1st Further Information

**Proposed Temporary Place of Recreation, Sports or Culture with Ancillary Facilities
for a Period of 3 Years and Associated Filling of Land in "Agriculture" Zone,
Lots 110 S.A RP, 110 S.B, 110 S.C, 110 S.D ss.1 S.A, 110 S.D ss. 1 RP, 110 S.D ss.2, 110 S.D ss.3
and 110 S.D RP in D.D. 112, Shek Kong, Yuen Long, New Territories**

(S.16 Planning Application No. A/YL-SK/400)

Response-to-Comment

FSIs PROPOSAL

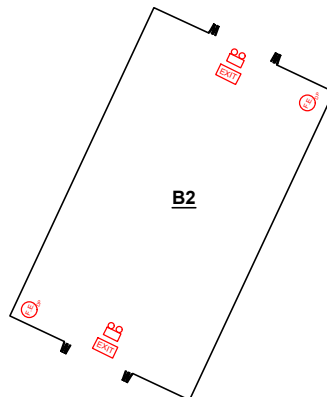
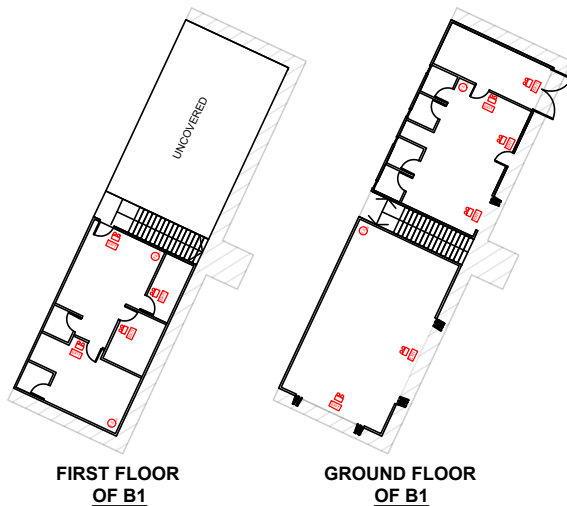
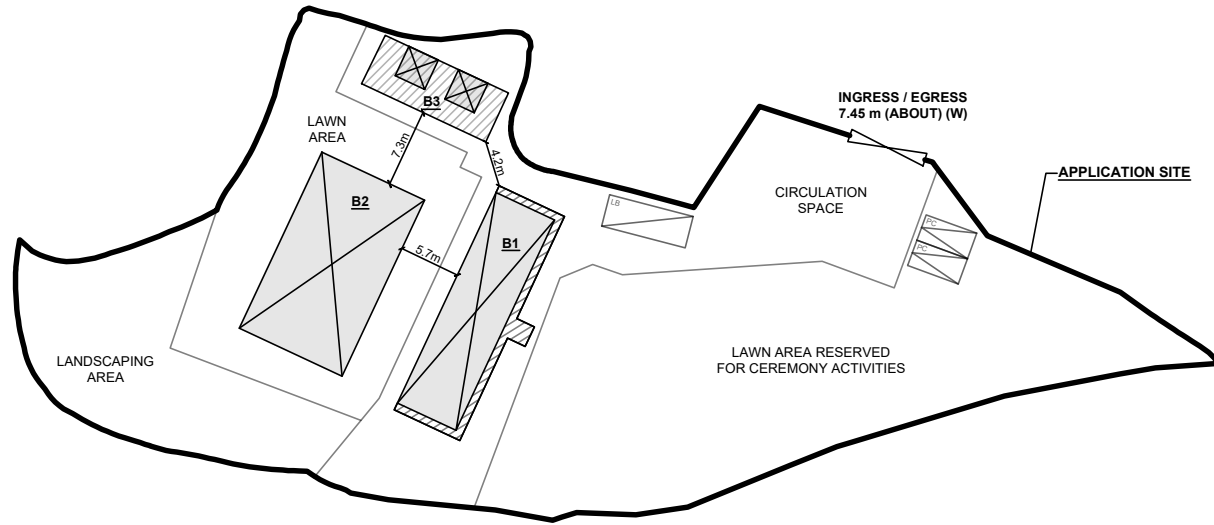
Departmental Comments		Applicant's Responses
1. Comments of the Director of Fire Services (D of FS)		
(a)	Structures on the same site are regarded as adjoining structures if they are less than 1.8 m apart. In this regard, sprinkler system, modified hose reel system, fire alarm system, emergency lighting, directional and exit signs and portable fire extinguishers shall be provided to Structures B1 and B2 as the total floor area exceeds 230 m ² ; and	Kindly note that Structures B1 and B2 are about 5.7 m apart. As such, the floor area of each structure should be considered separately, where no structure has exceeded the total floor area of 230 m ² . Illustrations of the distance between each structure have been added onto the enclosed revised fire service installations (FSI) proposal at Annex 1 .

(b)	The standards and specification of the proposed directional and exit signs shall be revised to 'BS 5266-1:2016 and the FSD Circular Letter No. 5/2008'.	Noted. Please refer to the revised FSI proposal at Annex 1 .

DRAWING TITLE
PROPOSED DRAINAGE AND EXISTING ASBUILT DRAINAGE SYSTEM

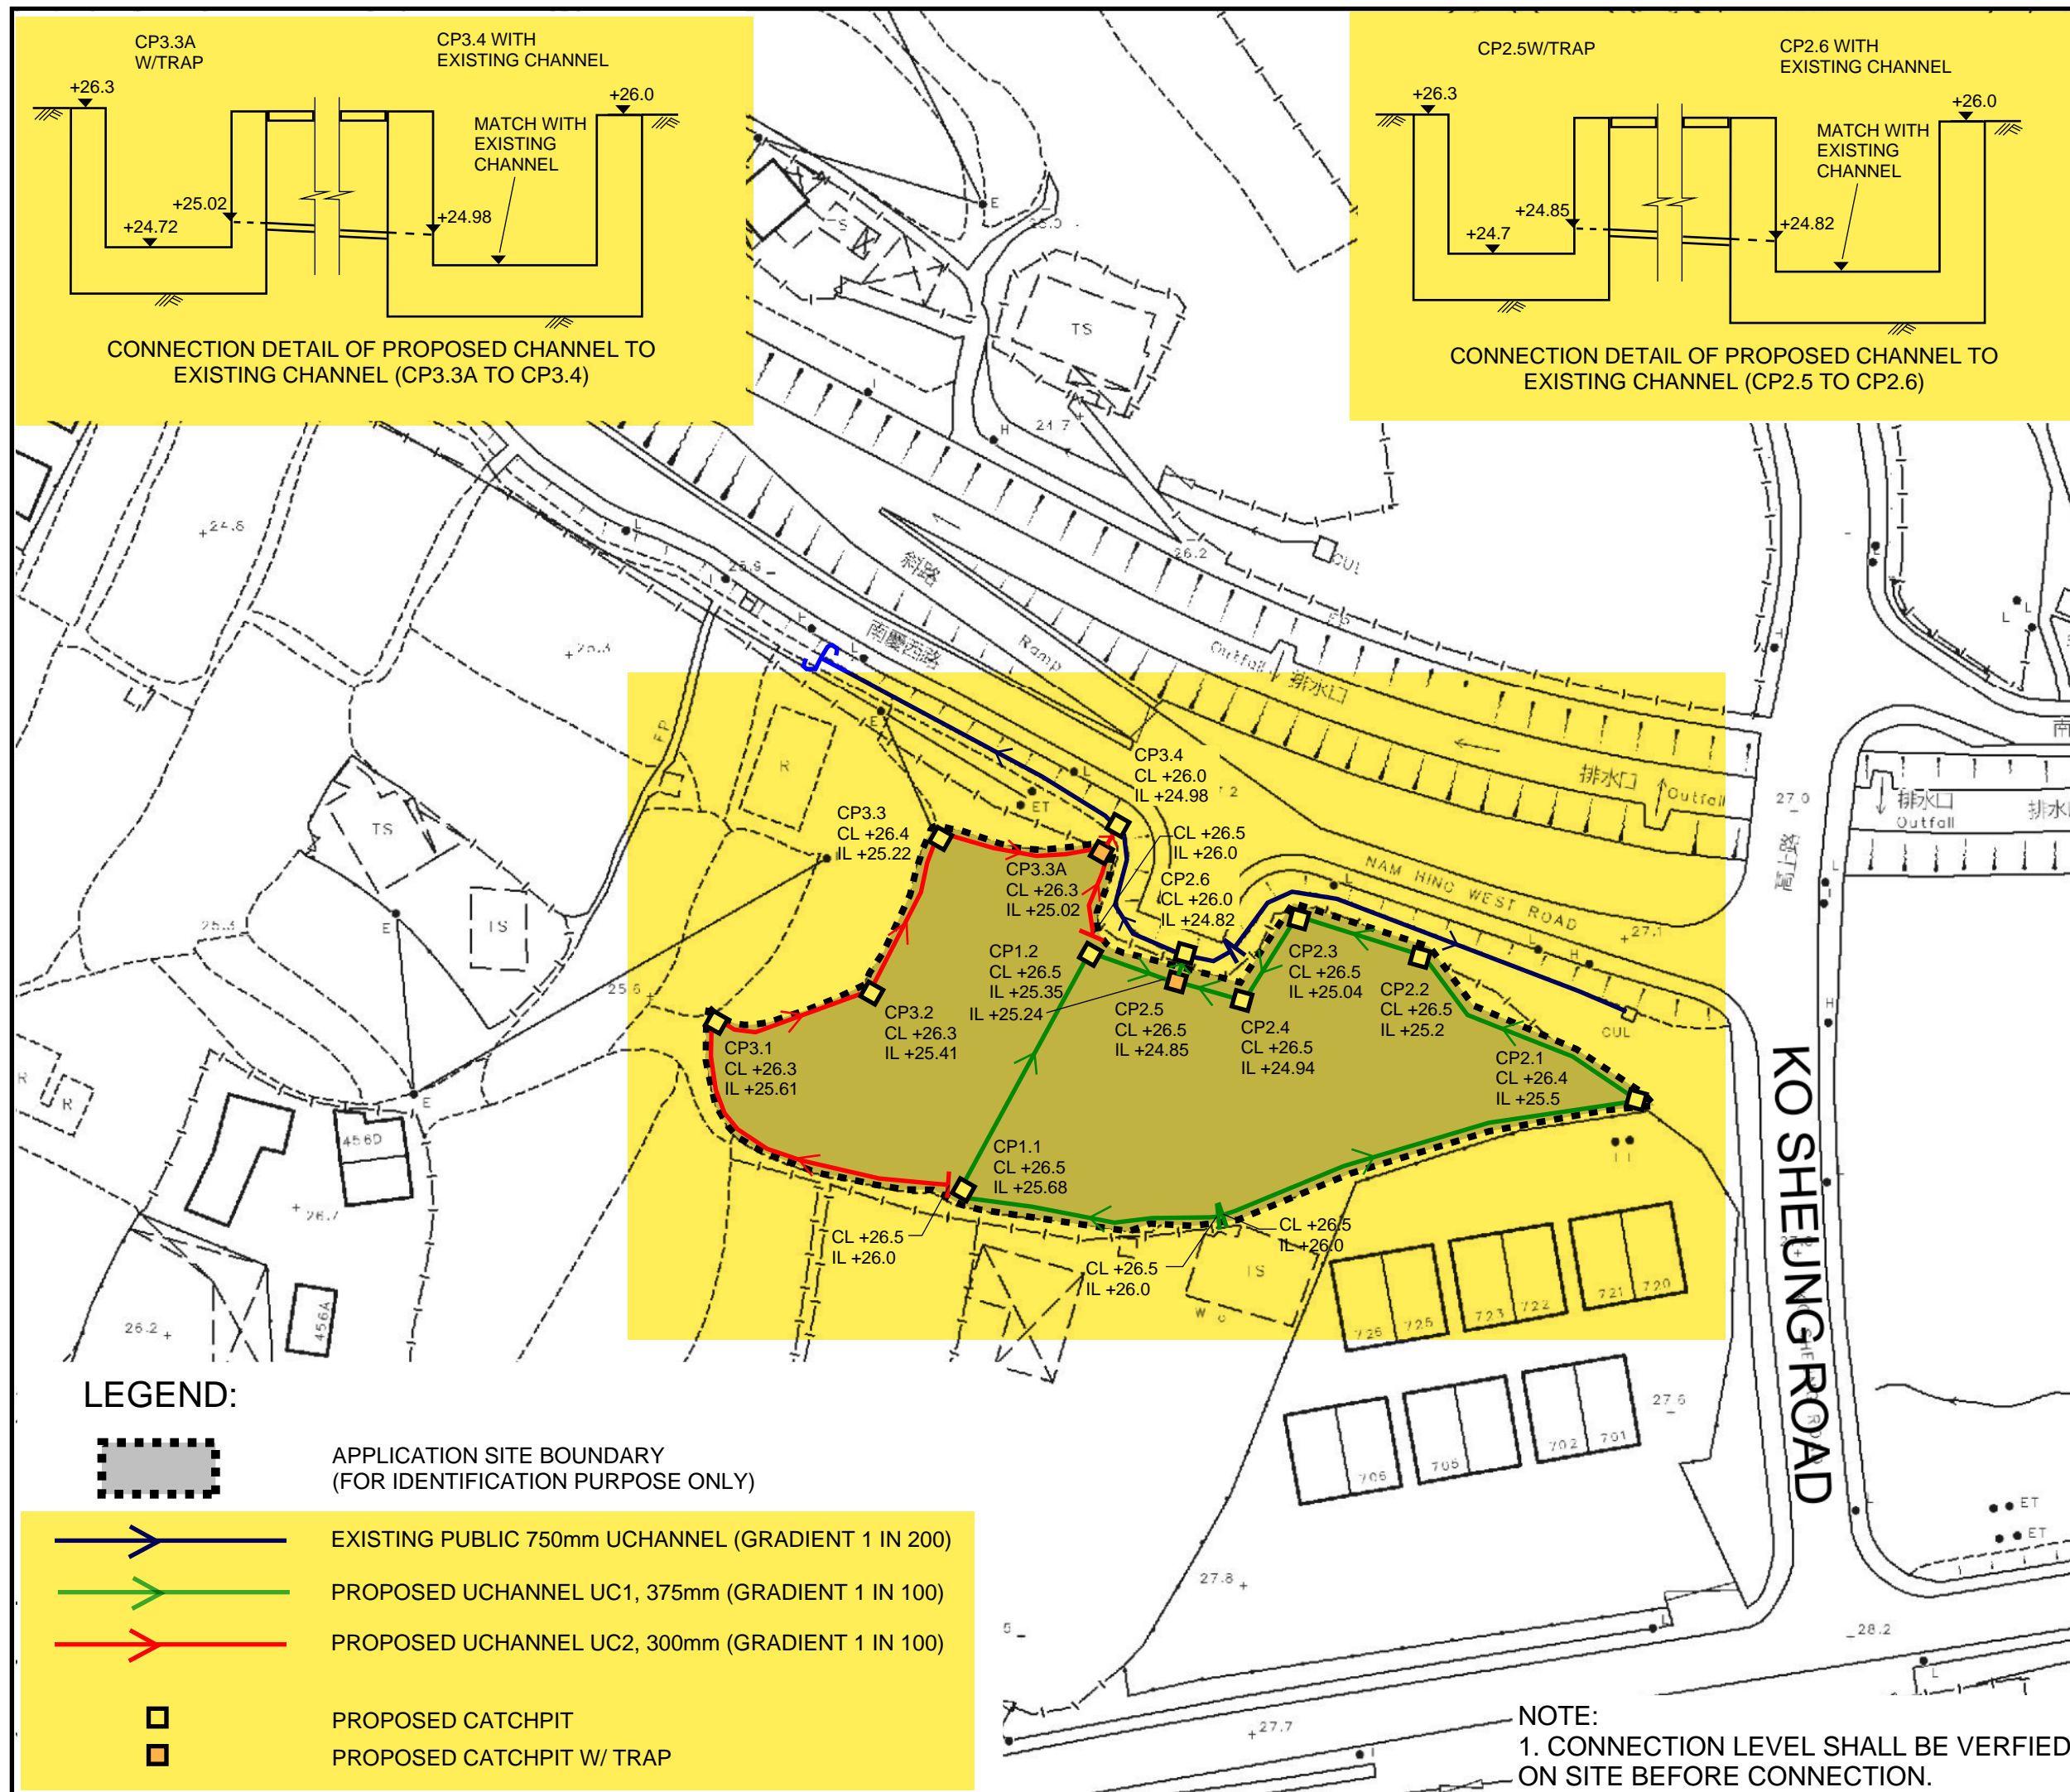
(e)	Please show the C.L at the starting points of the proposed drainage channels.	Noted. Please refer to updated Figure 3 in the revised drainage proposal.

(f)	Please show the connection details at discharge point and indicate all C.L., I.L. and catchpit/watercourse bottom level in the drawing.	Noted. Please refer to updated Figure 3 in the revised drainage proposal.

Revised Run-in/out Proposal

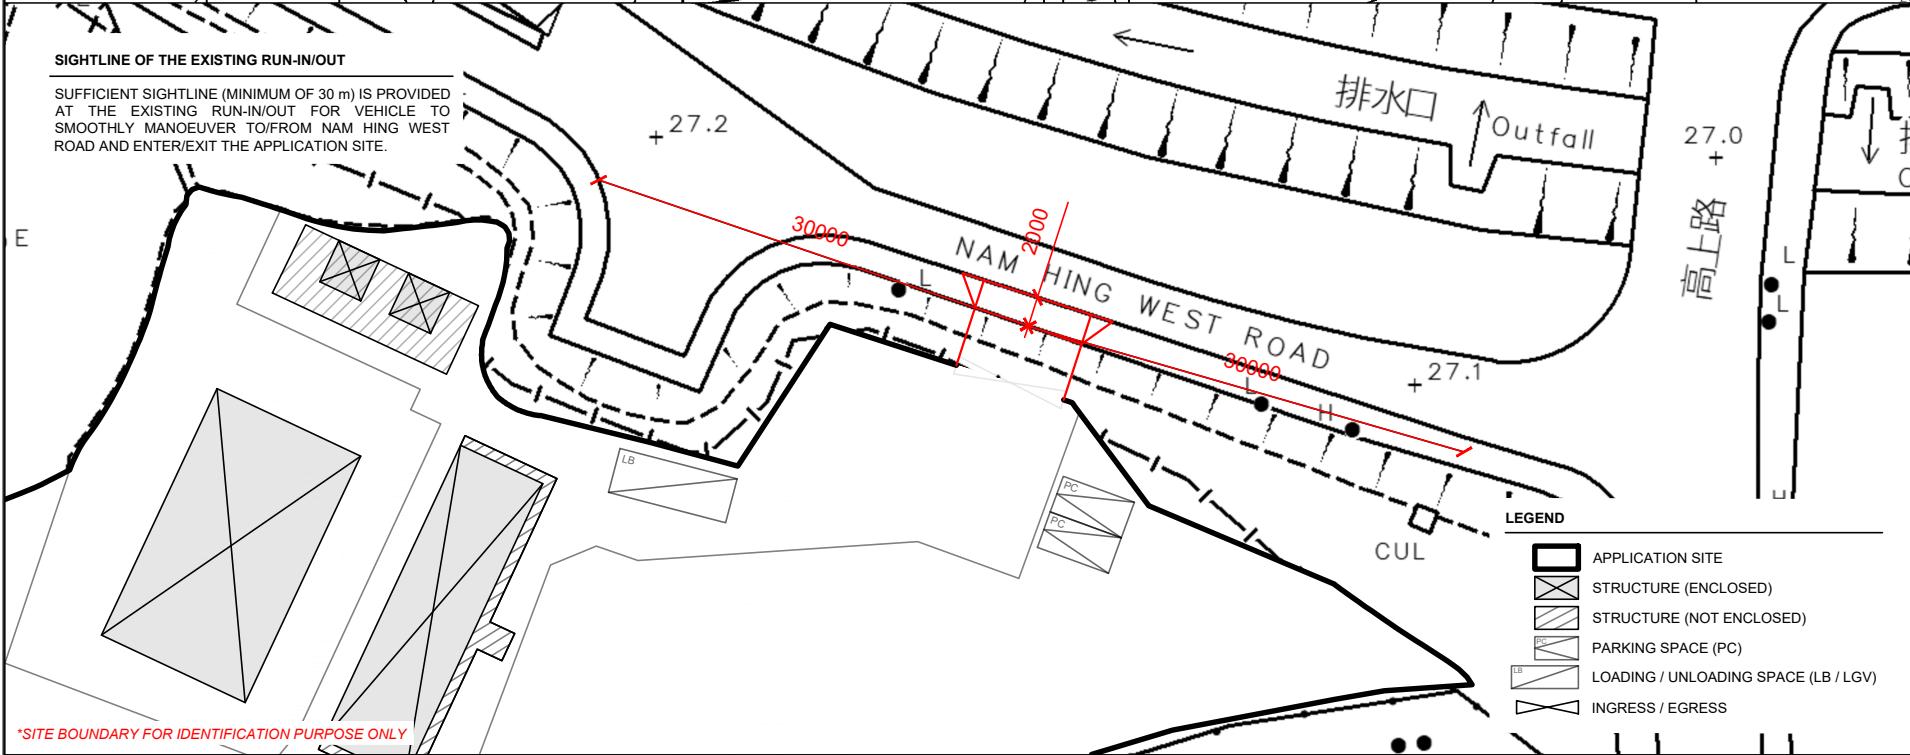
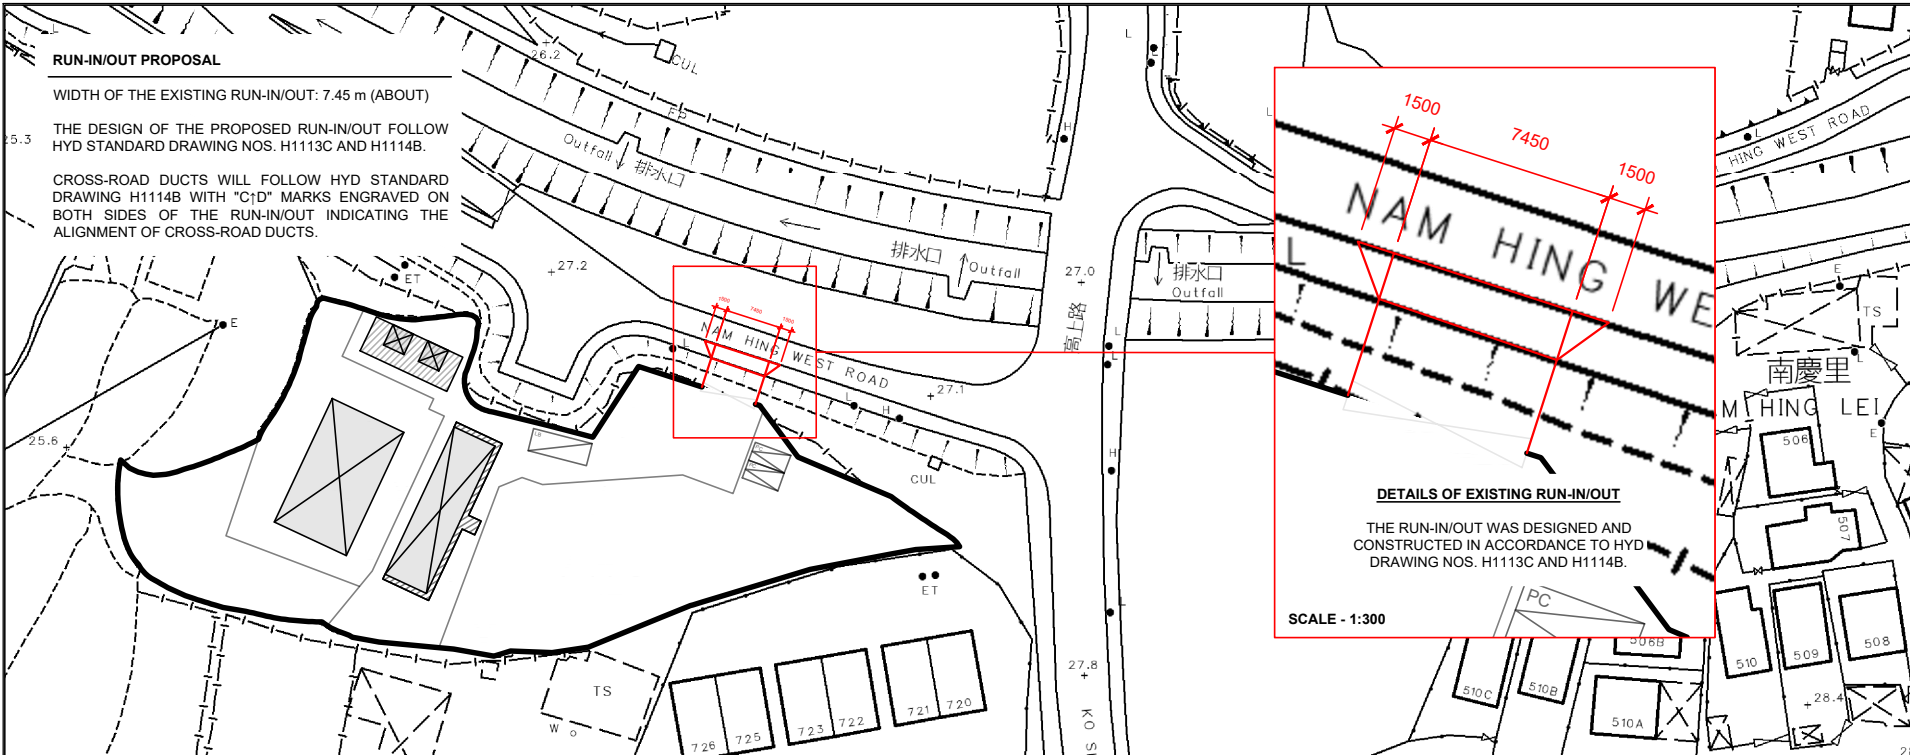
(b)	If the proposed access on Nam Hing West Road is approved by TD, the applicant should ensure a run-in/out is constructed in accordance with the latest version of HyD Standard Drawings no. H1113 and H1114, or H5133, H5134 and H5135, whichever set is appropriate to match with the existing adjacent pavement.	The applicant has submitted a revised run-in/out proposal (Annex 3) for HyD's consideration. Upon acceptance by HyD, the applicant undertakes to reconstruct the run-in/out in accordance with the latest version of HyD Standard Drawings.

(c)	From highways maintenance point of view, the run-in/out proposal on Page 30 of Appendix III of the planning statement is considered not acceptable given its lack of the necessary construction details. The existing run-in/out as pictured in the application were constructed under the previous application No. A/YL-SK/306 and they have not been accepted by this office from highways maintenance point of view. The as-built dimension was also found not consistent with that indicated on Page 30. The applicant should be reminded that it is his responsibility to provide proper run-in/out access to the site as soon as possible for the sake of road user's safety on public roads.

DWG. TITLE
LAYOUT PLAN

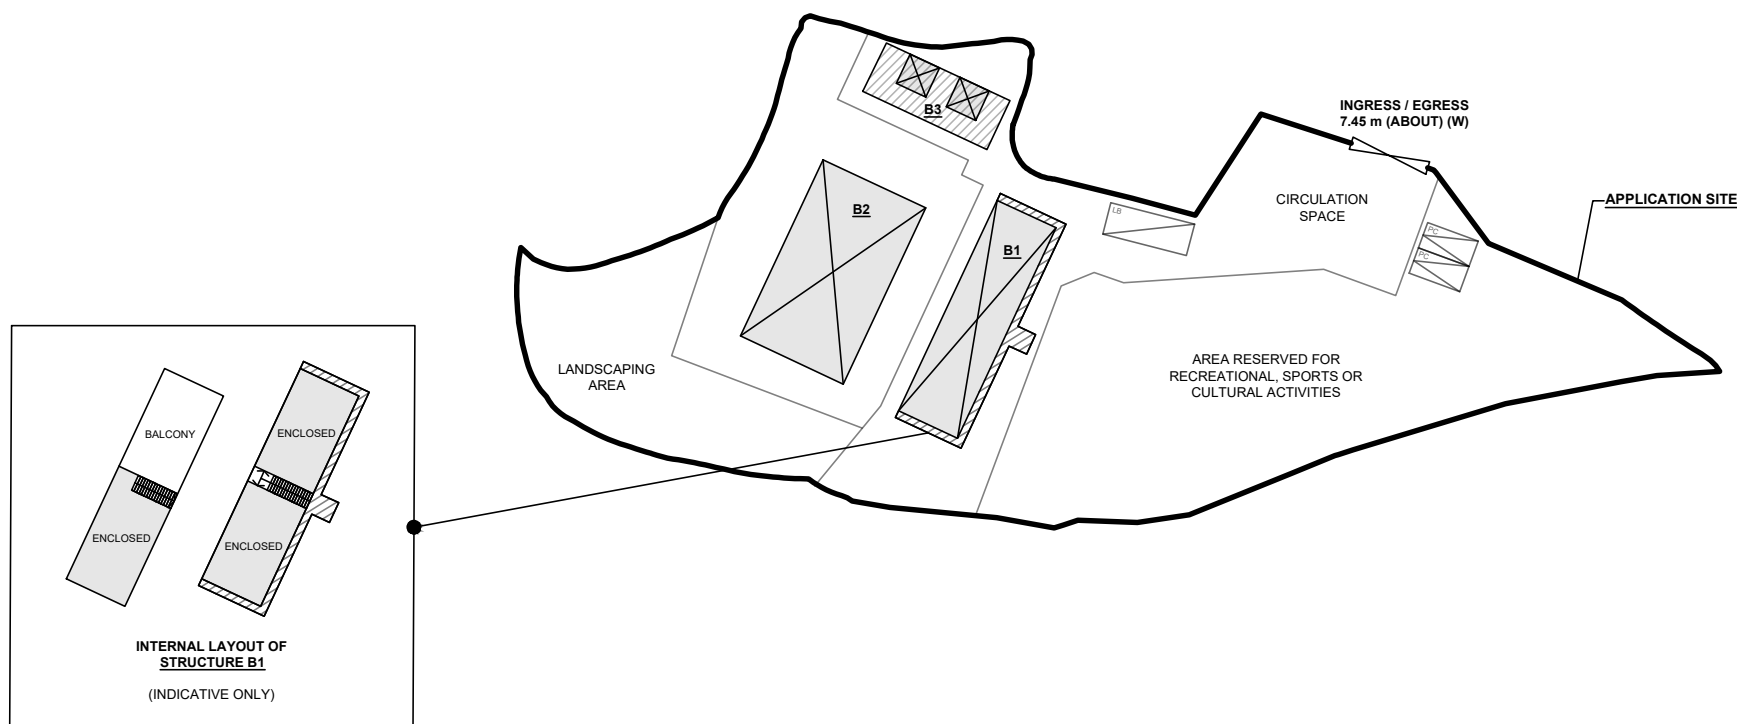
- (iii) In order to reflect the revised dimension in the run-in/out proposal, the applicant has submitted the revised layout plan and swept path analysis to rectify the width of the ingress/egress of the application site. The revised plans are enclosed at **Annex 4**.
